Project	IEEE 802.16 Broadband Wireless Access Working Group < http://ieee802.org/16 >	
Title	Corrections to STC mode in OFDM 256 PHY	
Date Submitted	June 25, 2004	
Source(s)	Atul Salvekar, Ph.D. Baraa Al-Dabagh Hassan Yaghoobi, Ph.D.	mailto:atul.a.salvekar@intel.com mailto:baraa.al.dabagh@intel.com mailto:hassan.yaghoobi@intel.com
	Intel Corporation CHP3-105 350 East Plumeria Dr. San Jose, CA 95134	
Re:	Supporting document for recirculation ballot #14b.	
Abstract	<p>In P802.16 REVd/D5 [1], an STC Preamble is only mandatory if there is an STC allocation in the frame. However, in order to get accurate maintenance values, for example power, an STC preamble should occur in a preceding frame. In order to alleviate the situation, it is recommended that if there is an STC allocation in frame K and there is no STC allocation in the preceding frame, K-1, then the BS must transmit an STC preamble as the last allocation in the preceding frame, i.e frame K-1. A second recommended item is to adjust the STC FCH so that it mirrors the FCH in normal transmission. This resolves the problem in the current standard that the MAP cannot necessarily be parsed in STC mode. The modifications are to be mad

Figure 1: Instability caused by using a single STC preamble for STC data transmission.

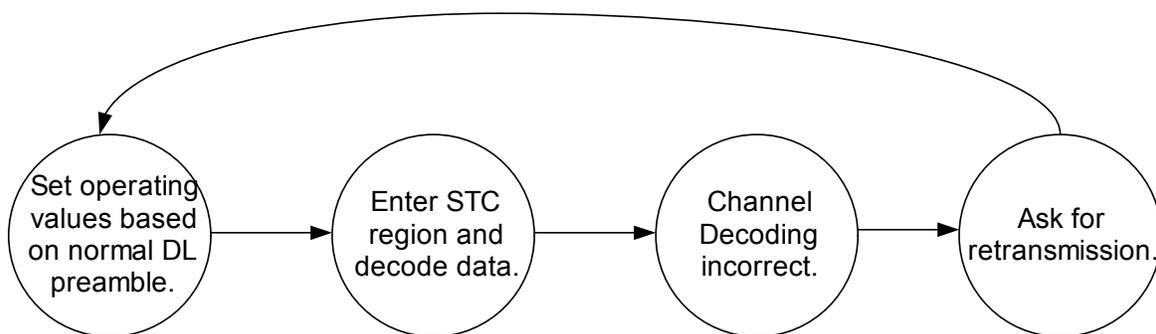
Suppose that during non-STC portions of the frame, the BS transmits on antenna 1. The SS sets operating values based on the DL preamble. Once STC enabled transmission begins, both antenna 1 and antenna 2 transmit, which may make these operating values faulty. This can result in incorrect decoding of the data. For instance the power from a single antenna could be over 20 dB less that that of a second antenna for uncorrelated Rayleigh Fading Channels. In this case, instability can exist as expressed in Figure 1.

Thus, we suggest that in the case that there is STC encoded traffic in a specific frame, K , without STC encoded data traffic on the previous frame, $K-1$, the preceding BS DL subframe, $K-1$, shall contain an STC zone, in which the STC zone consists of only an STC preamble without FCH-STC. The SS will be able to determine that there is no FCH-STC by determining that the STC preamble is at the end of a frame. This is expressed in for TDD transmission in Figure 2.

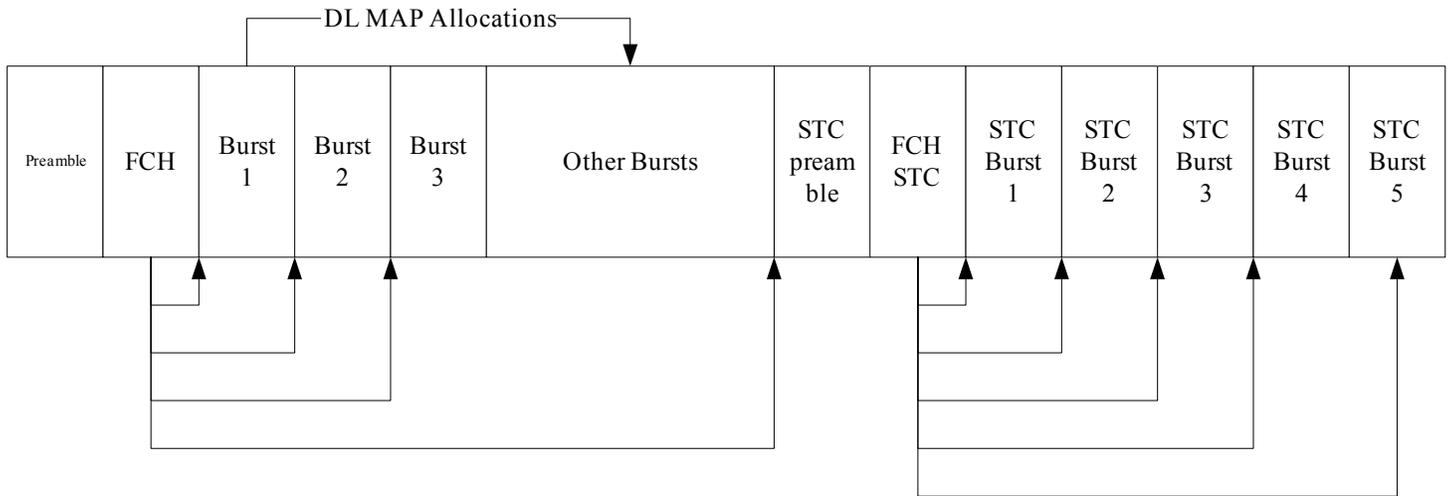
The STC zone starts from a preamble and an STC encoded FCH-STC burst, which is one symbol with the same payload format as specified in Table 239. The FCH-STC burst is transmitted at BPSK rate $\frac{1}{2}$. It is followed by one or several STC encoded PHY bursts. The first burst in the STC zone may contain a DL-MAP applicable only to the STC zone. If DL-MAP is present, it shall be the first MAC PDU in the payload of the burst.

In the case that there is STC encoded traffic in a specific frame, K, without STC encoded data traffic on the previous frame, K-1, the preceding BS DL subframe, K-1, shall contain an STC zone, in which the STC zone consists of only an STC preamble without FCH-STC. The SS will be able to determine that there is no FCH-STC by determining that the STC preamble is at the end of a frame.
